SAN FRANCISCO UNIFIED SCHOOL DISTRICT
FACILITIES DESIGN AND CONSTRUCTION

ADDENDUM NO. 1

PROJECT: Bret Harte E.S. Interior Improvements **DATE:** April 1, 2013
1035 Gilman Avenue, S.F. 94124

SHEET NUMBER
SK1

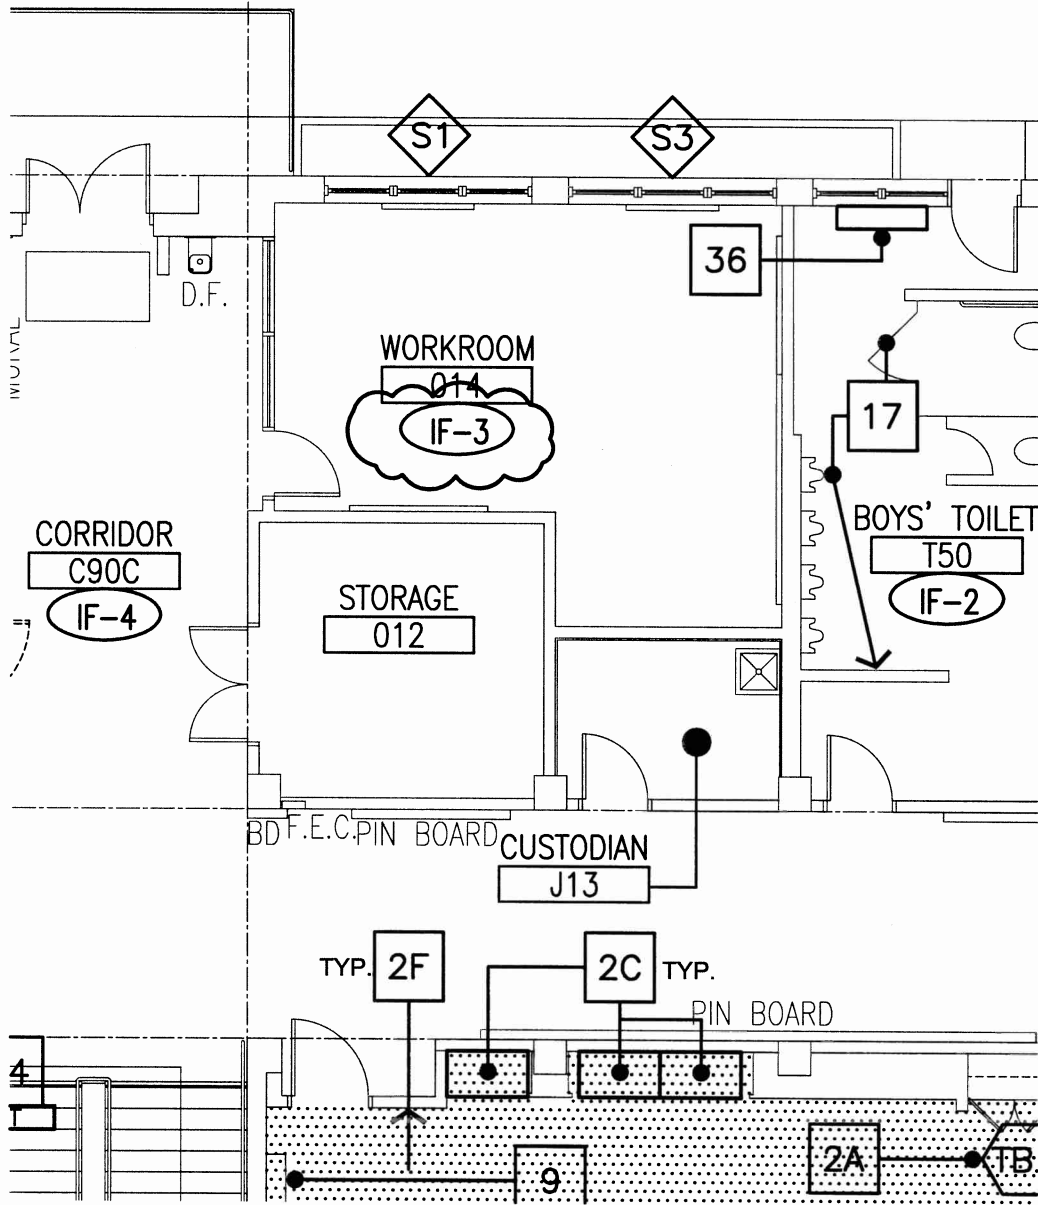
Reference: DRAWING A2, BUILDING A PARTIAL LOWER FLOOR PLAN
Description: Change Interior Finish Paint Key from 'IF-0' to read 'IF-3' in Workroom 014. Refer to drawing AD1-SK1.

SK2

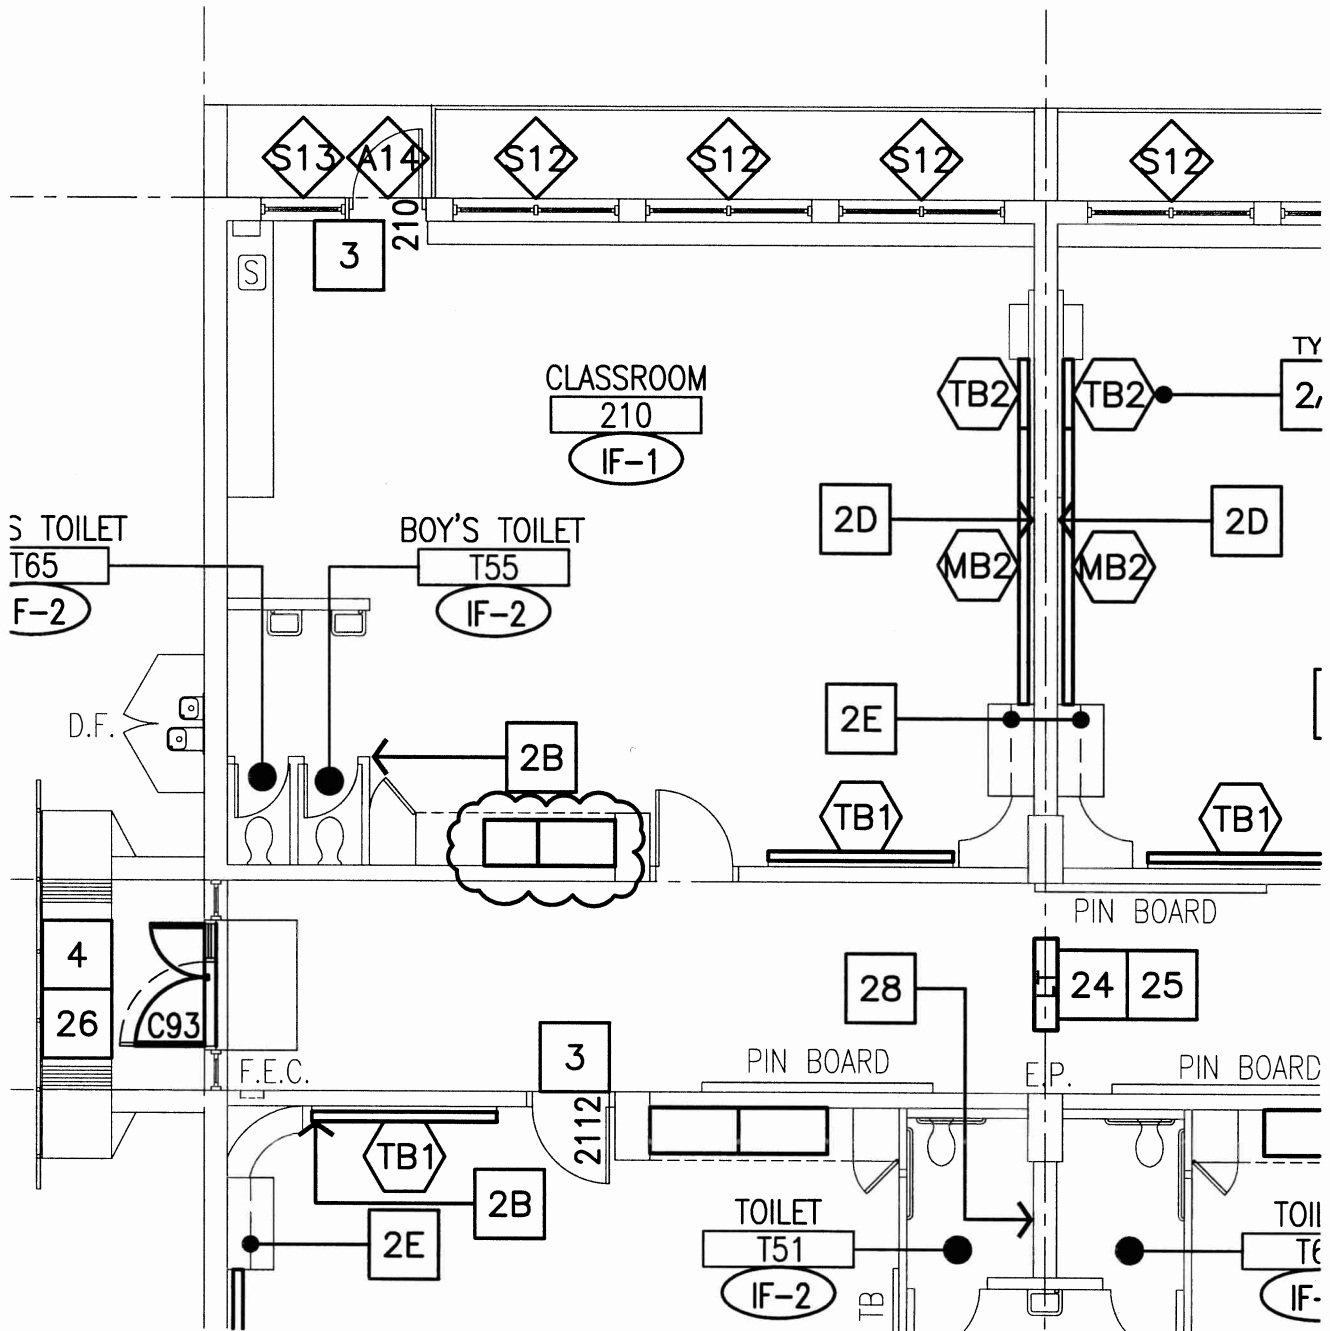
Reference: DRAWING A6, BUILDING B FLOOR PLAN
Description: Add two wood cubicles in Classroom 210. One unit shall be 40" wide per detail 3/A9. The 2nd unit shall be 28" wide without a vertical divider per detail 3/A9, similar. Refer to drawing AD1-SK2.

SK3

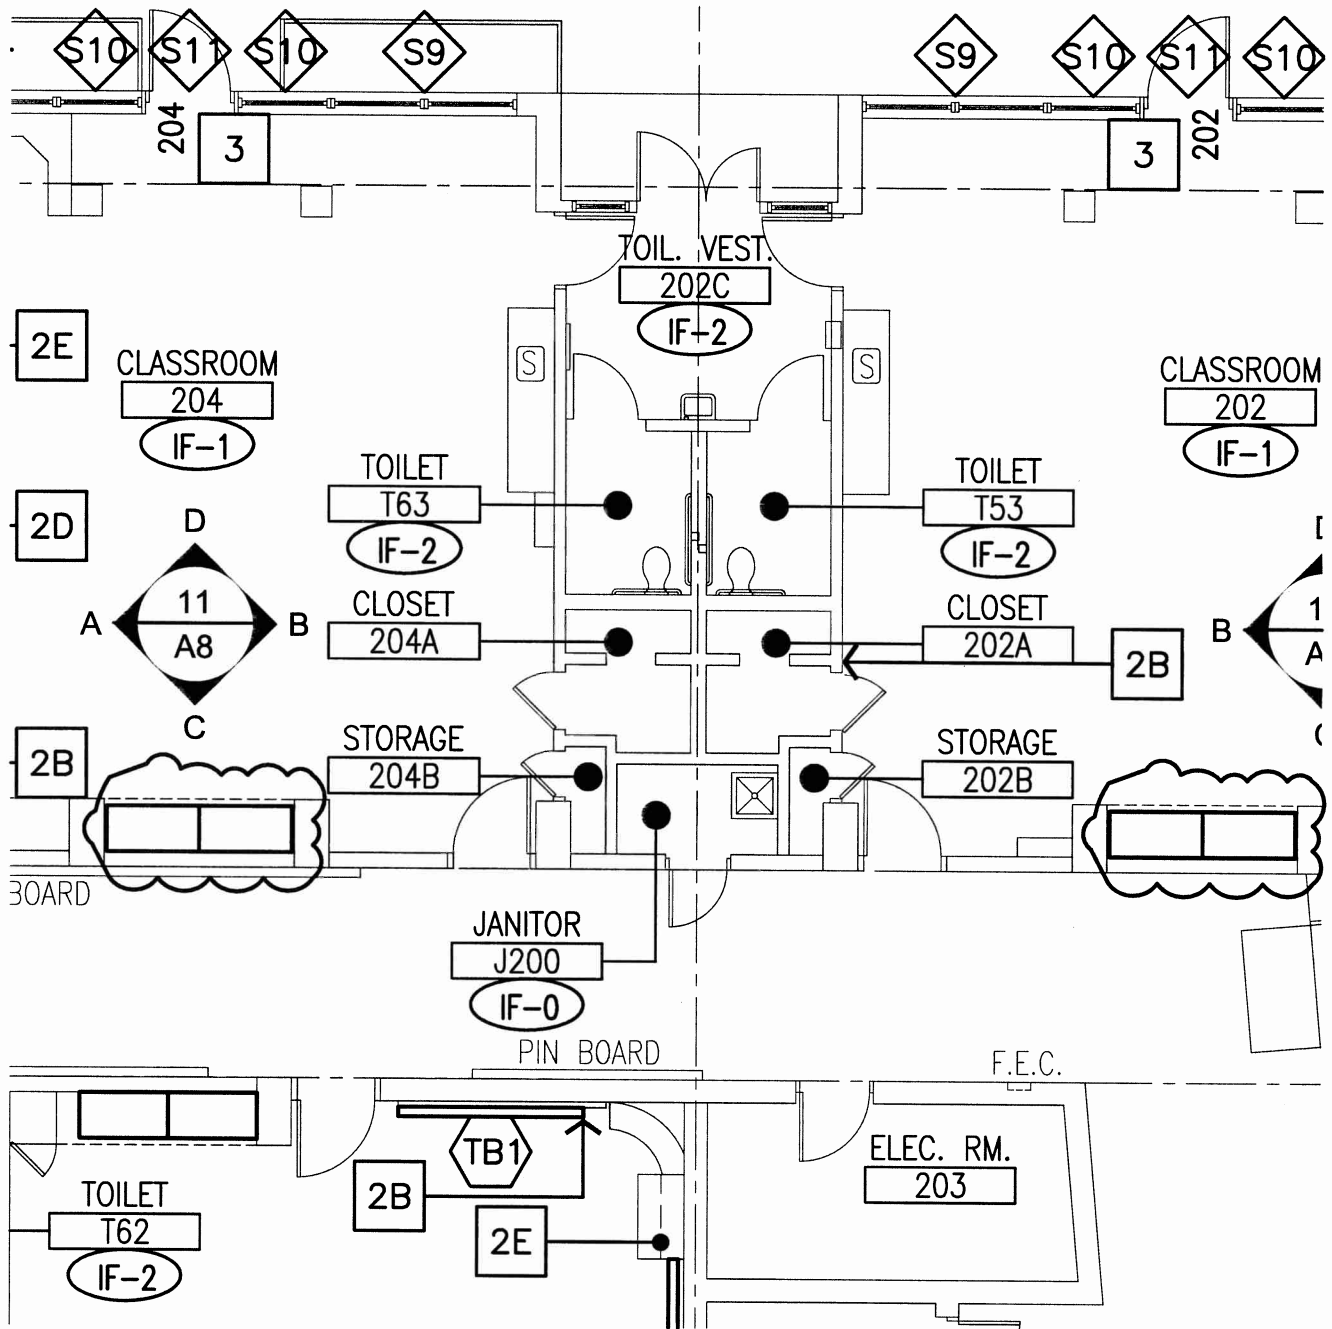
Reference: DRAWING A6, BUILDING B FLOOR PLAN
Description: Add two wood cubicles in Classroom 202. Each unit shall be 48" wide per detail 3/A9. Refer to drawing AD1-SK3.

Reference: DRAWING A6, BUILDING B FLOOR PLAN
Description: Add two wood cubicles in Classroom 204. Each unit shall be 48" wide per detail 3/A9. Refer to drawing AD1-SK3.

SK4

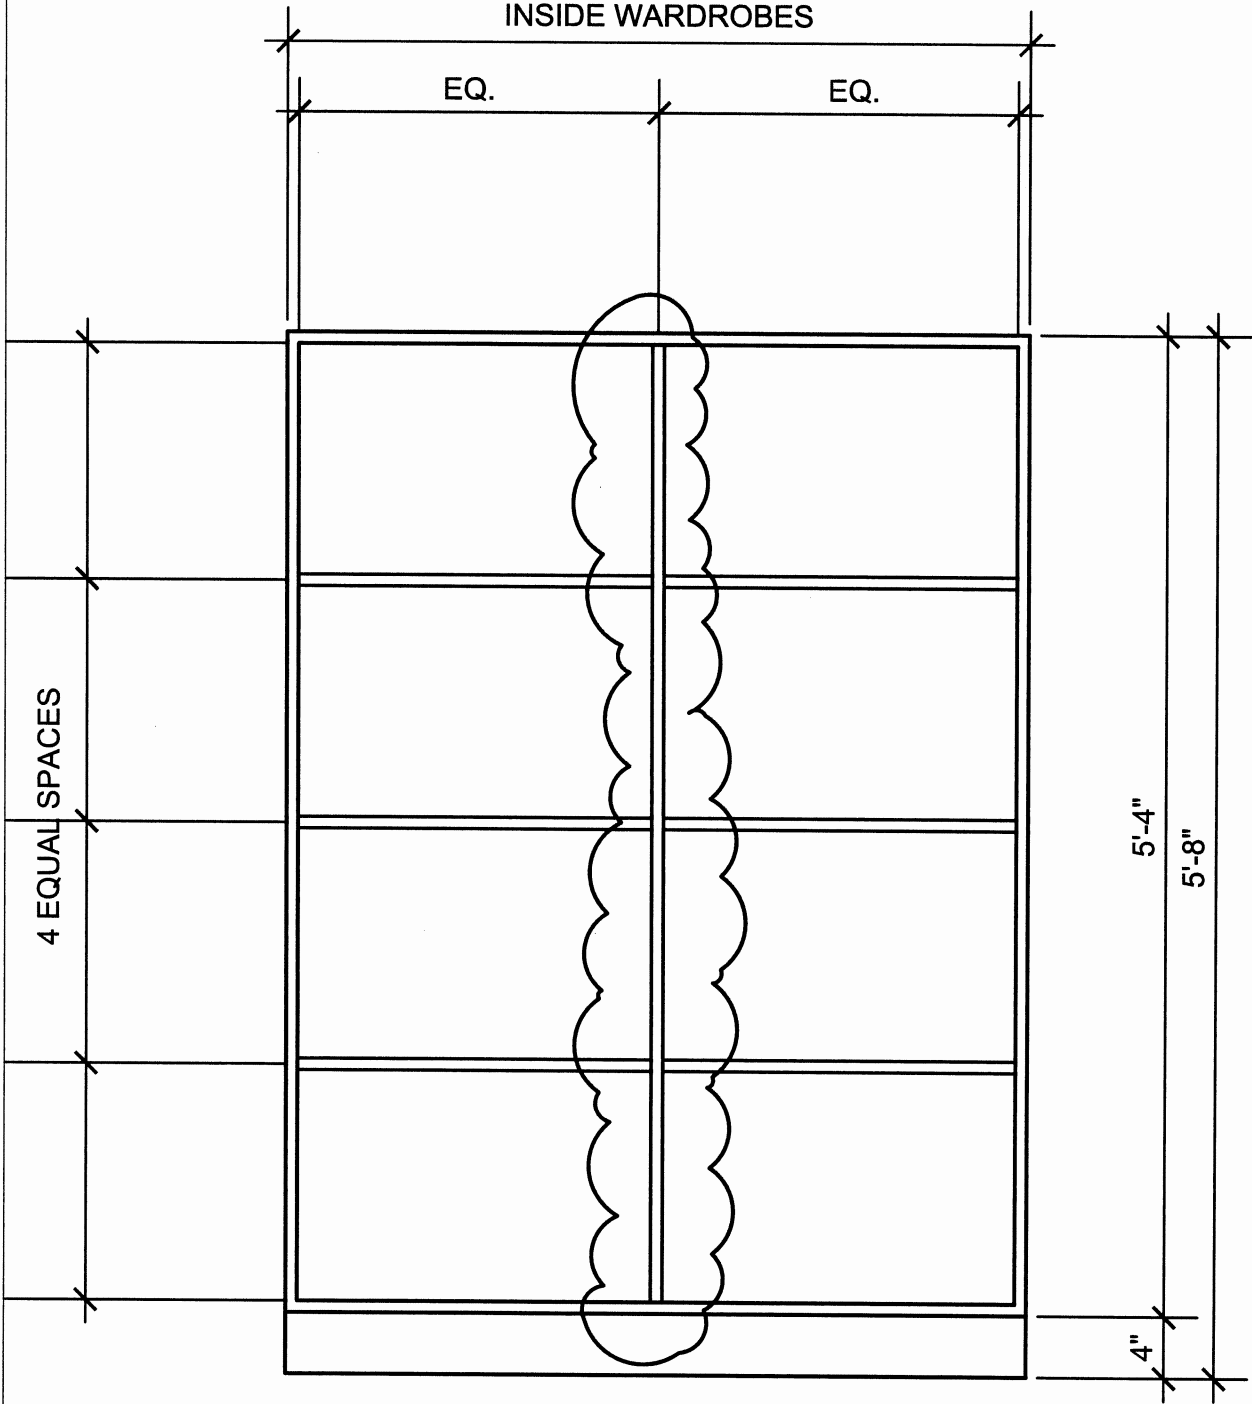
Reference: DRAWING A9, DOOR SCHEDULE AND DETAILS
Description: Revise detail 3/A9 to have one vertical divider per drawing AD1-SK4.

4'-0", FIELD VERIFY THAT IT FITS
 INSIDE WARDROBES
